STP Post-meeting Notes for January 26-27, 2012 Public Meeting

Resolutions & Comments

Fig1. The schematic representation of PRA & CASA Grande in the STP Risk-Informed GSI-191 project

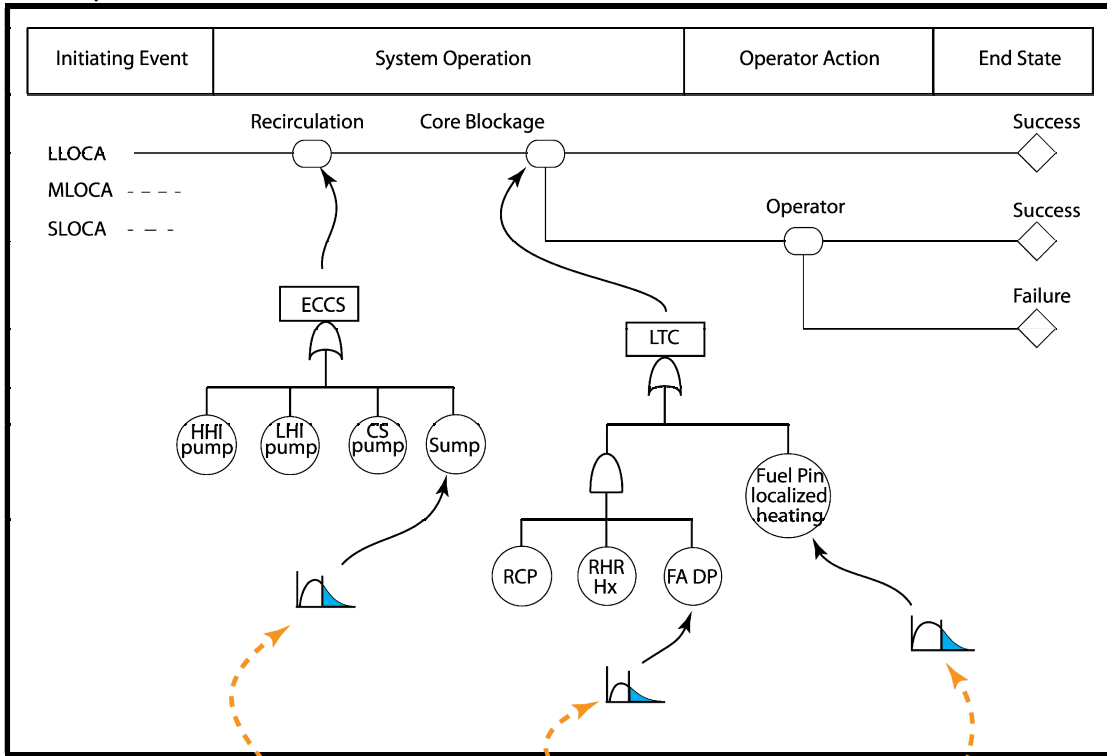
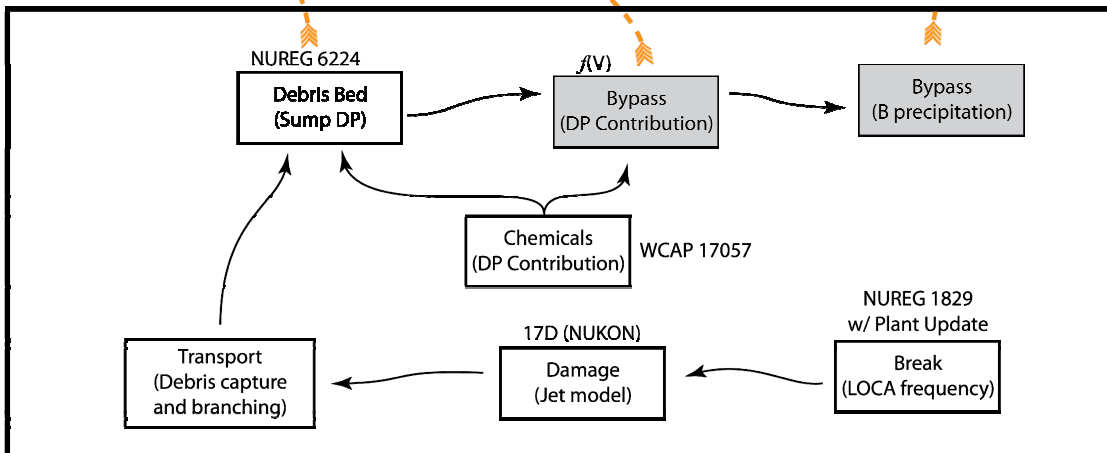
In view of this, the response to the question/comment about the cut sets in this project would be “we have the typical cut sets of Power Plant PRA”

And the response to the comment on CASA Grande being a black box is that “CASA Grande is **not** a black box but is, in fact, instrumental in opening the black boxes of two important events in the scenarios of a Power Plant PRA (i.e. recirculation and core blockage) by model-based estimations of the likelihood of their underlying basic events”.

Figure (1), on the next page, shows the schematic interrelationship of PRA and CASA Grande in the STP Risk-informed GSI-191 project. The figure does not attempt to cover all PRA scenarios (to avoid complexity with the figure). The main purpose is to present and to clarify the relationship between PRA and CASA Grande.

In the integrated model, developed in this project, PRA is located at the top level of system analysis. This plant-specific PRA has the typical Power Plant Fault Trees and Event Trees covering hardware failures and operators' actions and so, has the typical PRA **cut sets**.

One important aspect of this project is that CASA Grande provides estimates for the likelihood of three basic events of Fault Trees in PRA:
